Village of Arlington Heights
Plat and Subdivision Committee
Community Room, 3rd Floor
Arlington Heights Village Hall
33 S. Arlington Heights Road
Arlington Heights, IL 60005
April 26, 2017
6:45 PM

- A. CA Ventures - Sigwalt St. Apartments - T1592
Rezoning From R-3 to R-7, Preliminary PUD,
Preliminary Plat of Resubdivison, Variations

VILLAGE OF ARLINGTON HEIGHTS
STAFF DEVELOPMENT
COMMITTEE REPORT

Temp File Number: T1592
Project Title: CA Ventures Sigwalt St
 Apartments
Address: 300 Block W. Sigwalt St

Context Site Plan

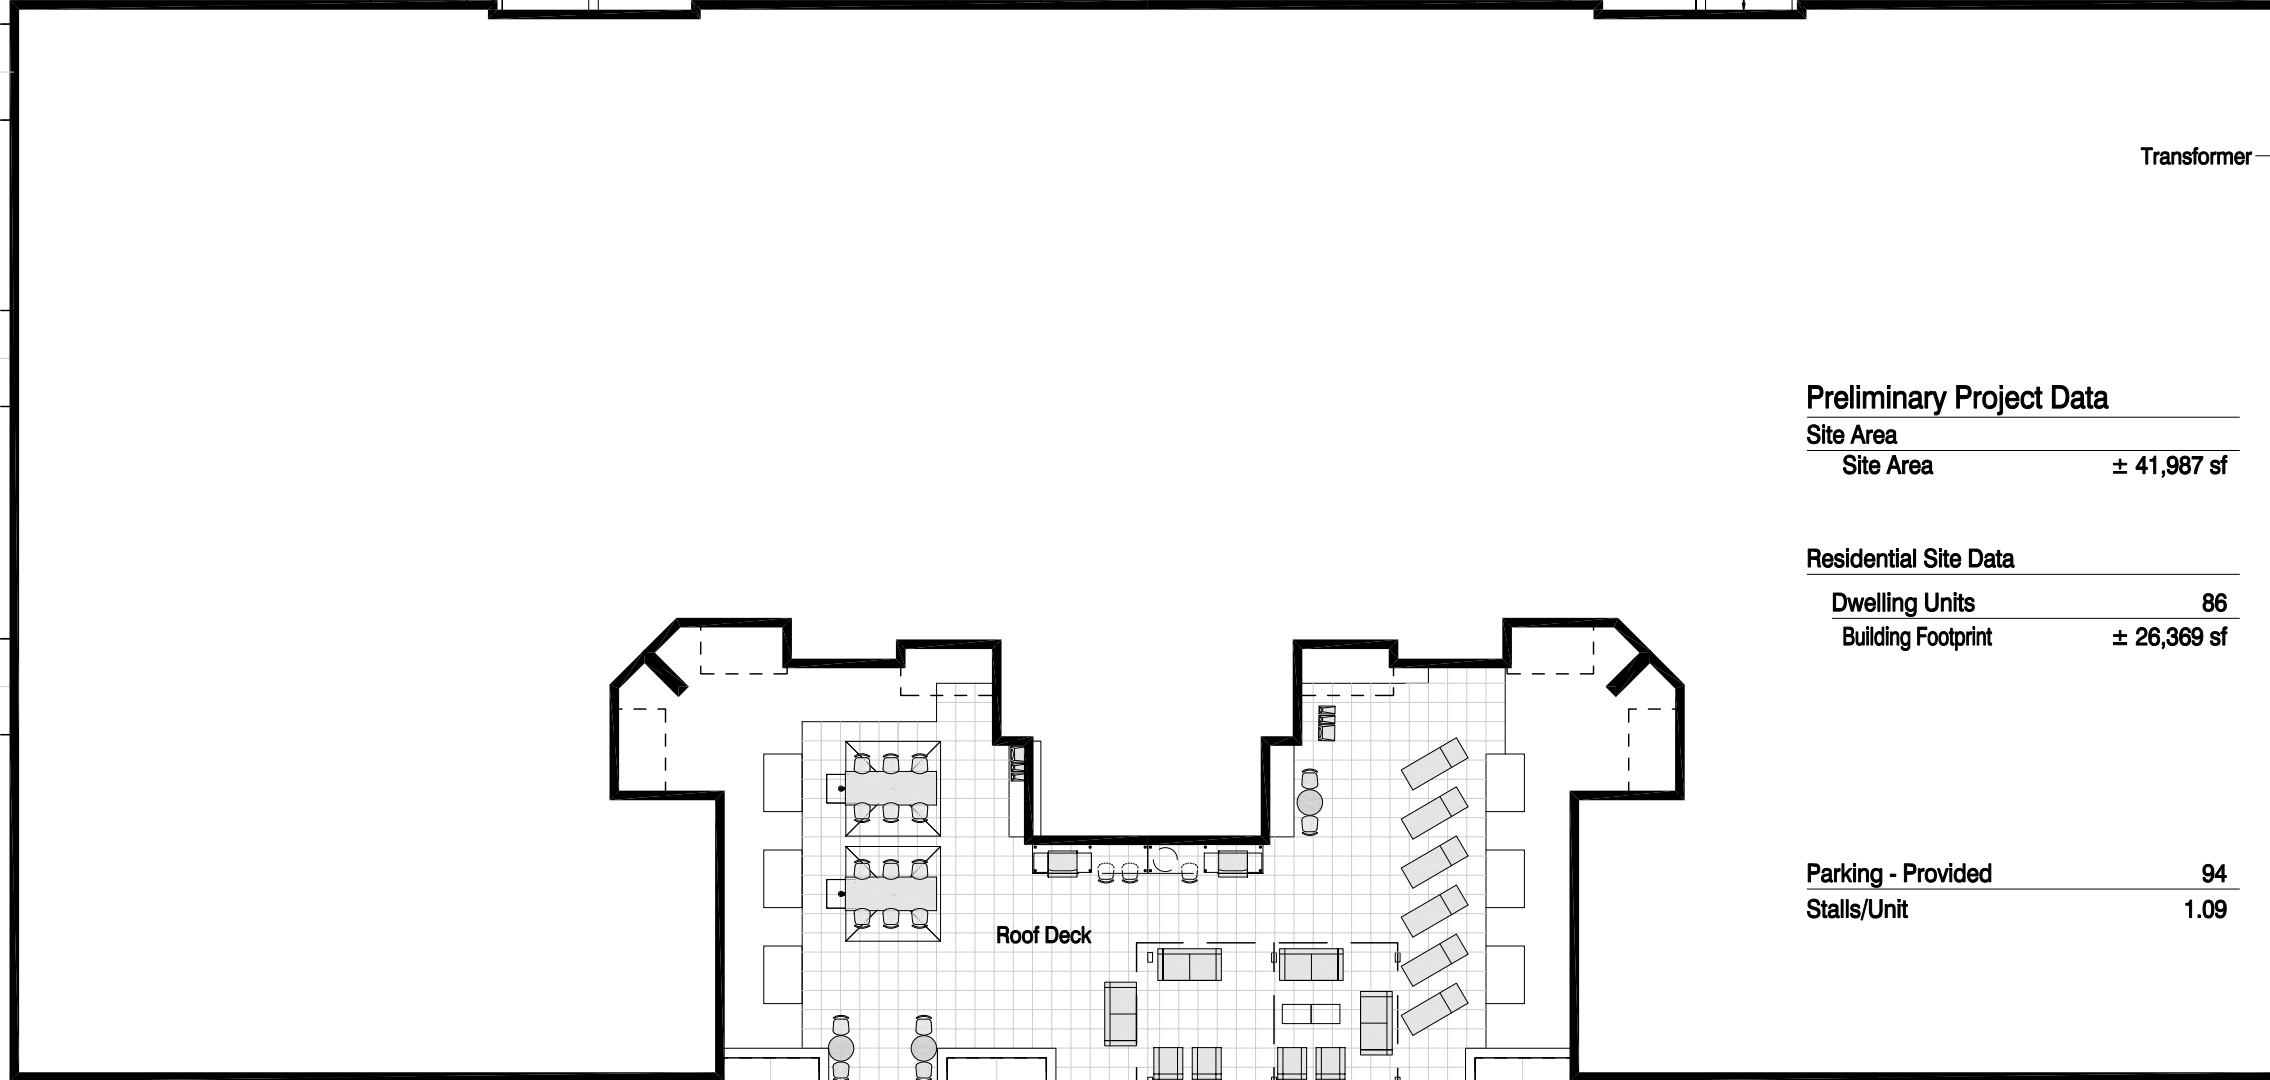
- **Variations from Chapter 28, Section 5.1-7.6 Required Minimum Yards:**
Interior Side Yard (north): 35 feet required, 18.4 feet proposed
Front Yard (Highland): 45 feet required, 8.5 feet proposed
Front Yard (Chestnut): 45 feet required, 13.7 feet proposed

As with the other variations that have been identified in this report, the Petitioner will need to provide a written justification prior to Staff rendering a final recommendation. It should be noted that there are no plans to widen the physical streets along Highland or Chestnut, therefore the 8 feet of land dedicated will remain as green space. The proposed setback from the Chestnut Avenue east curb line to the building is 33.7 feet. The proposed setback from the Highland Avenue west curb line to the building is 22.5 feet. The proposed setbacks are consistent with other R-7 developments.

Site Plan

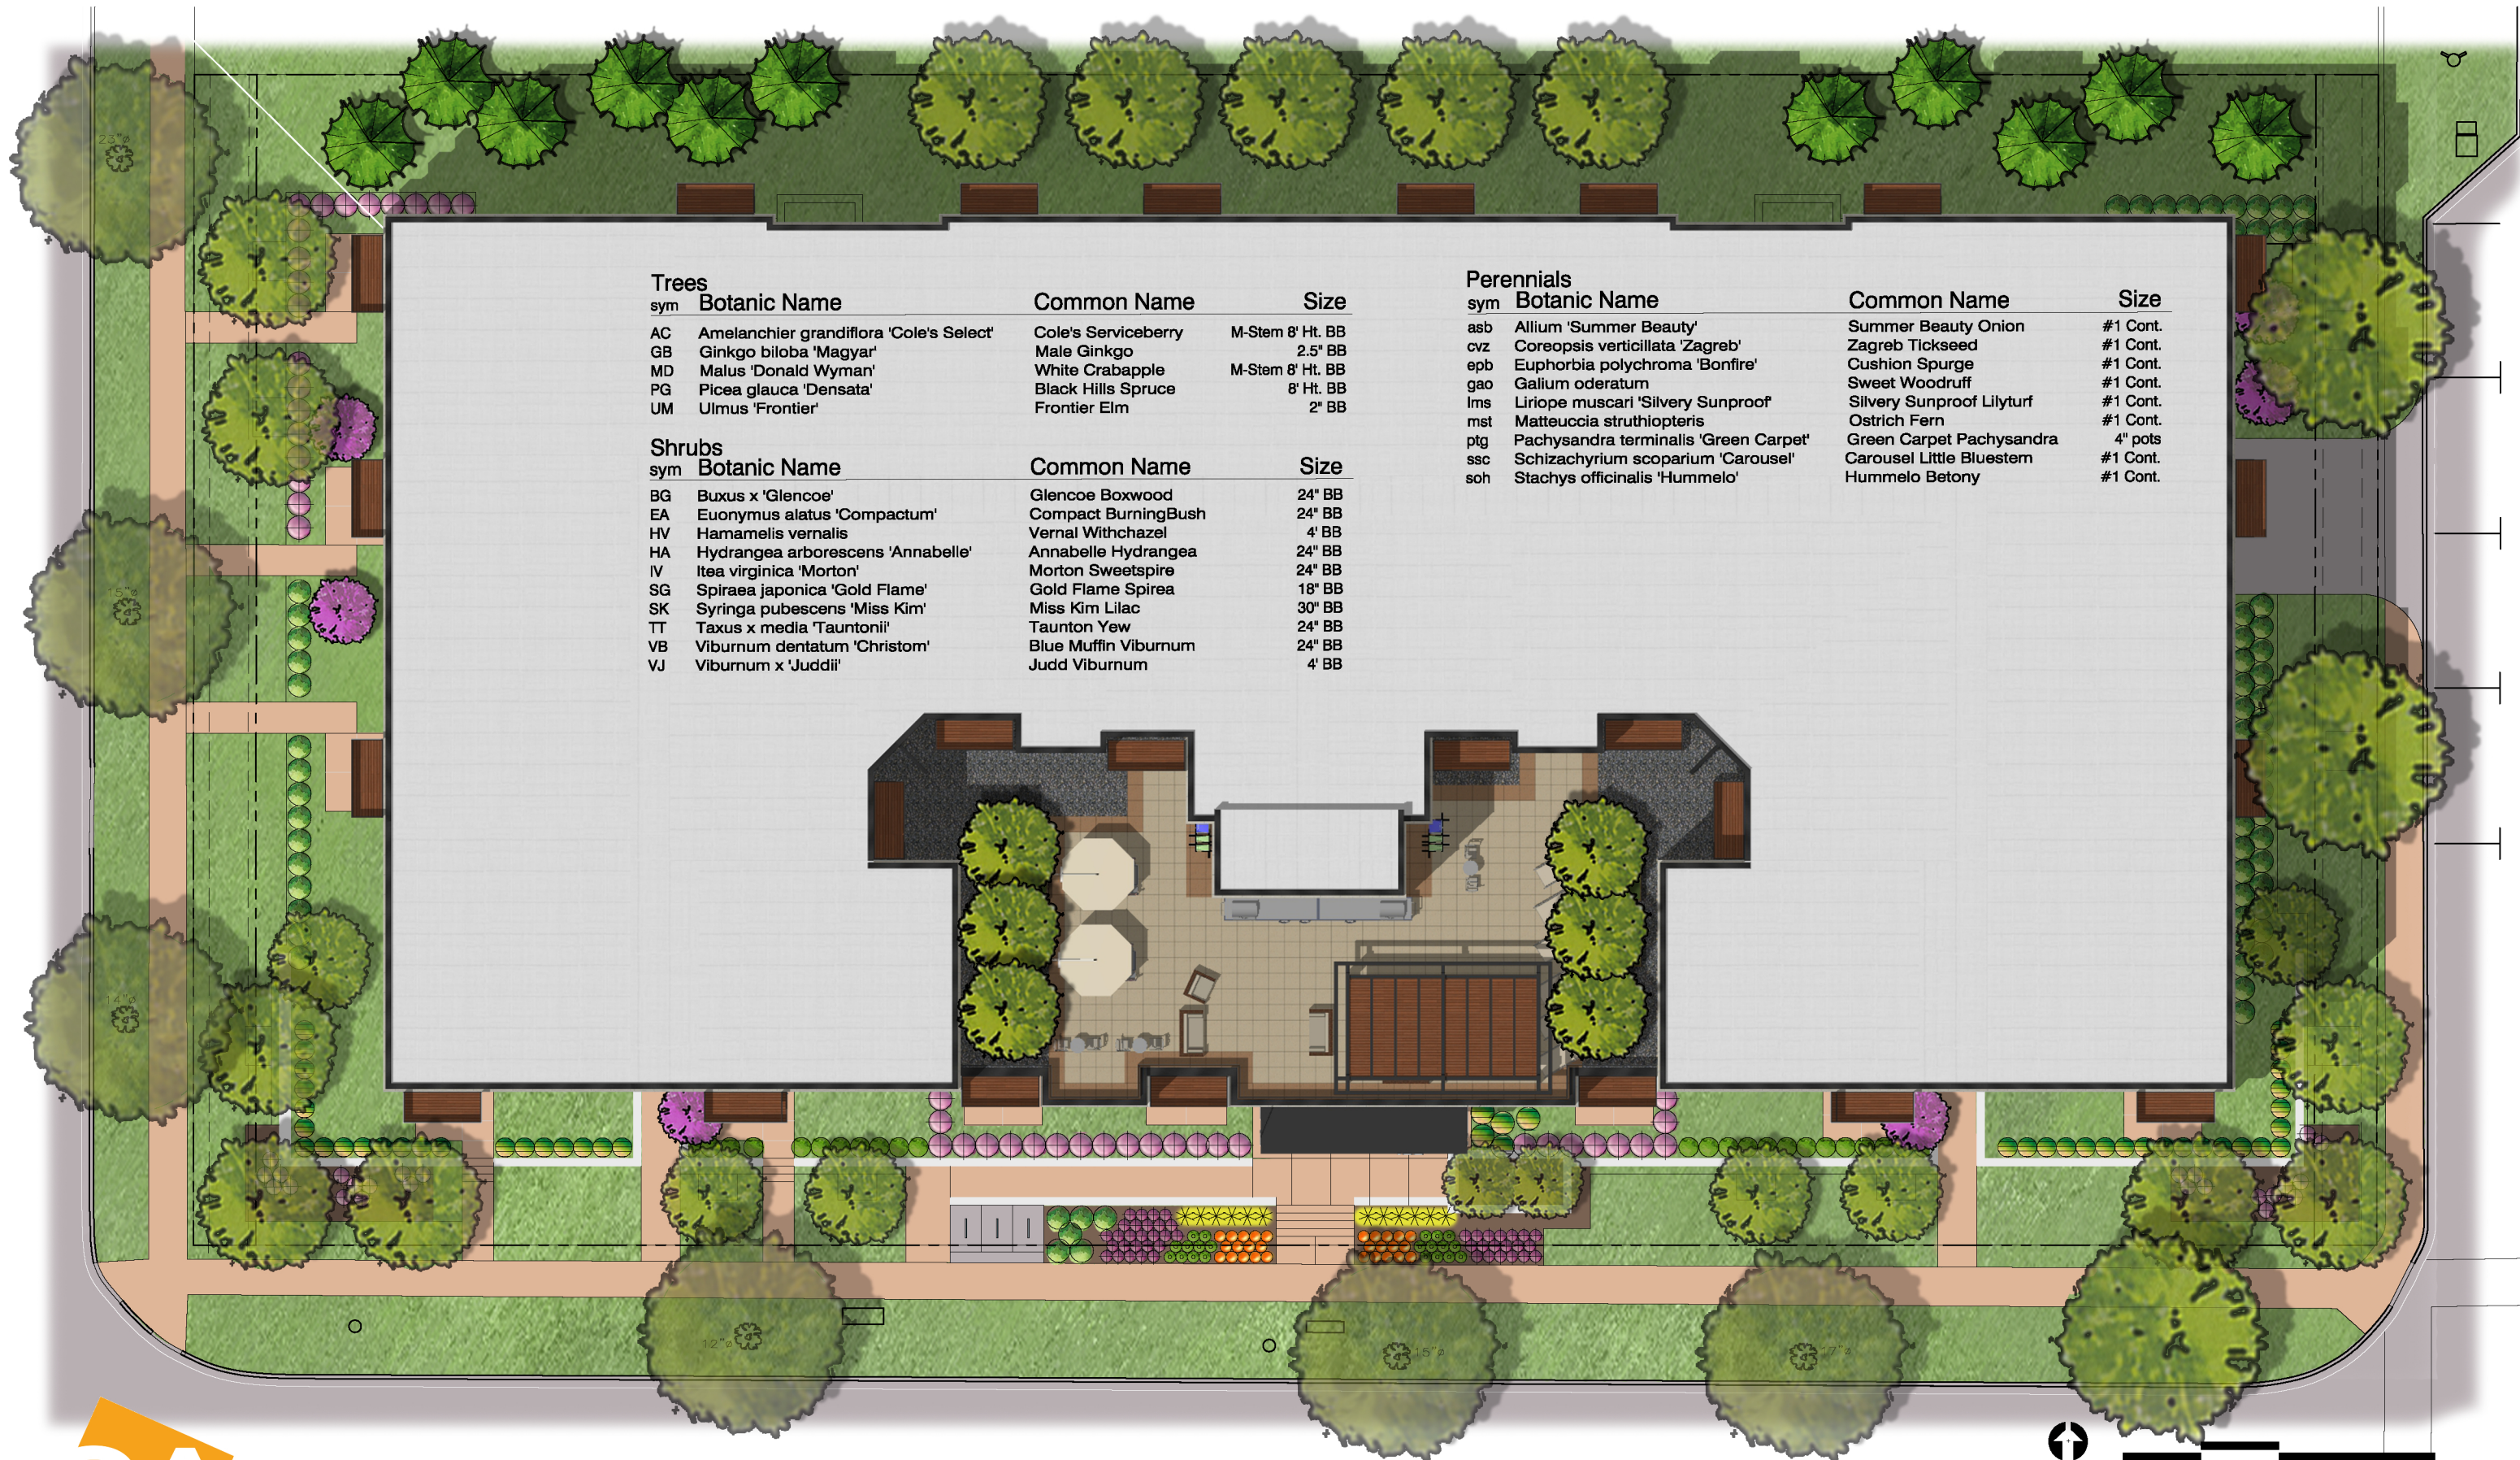
The proposed development requires variations to the east and west yards and the interior side yard setback (north). The exterior side yard along Sigwalt Street meets code. Table A attached to this report lists the code standards. The existing property is 280 feet east to west, and 150 feet north to south. After the required land dedication for additional right of way, the site length decreases to 264 feet thus increasing the setback variations along Highland and Chestnut.

Staff has recommended to the developer that the Chestnut setback be increased to 17 feet and the north setback increased to 20 feet.

In addition, there are existing utility poles running north to south in the middle of the development site which will need to be abandoned, or relocated if in use.
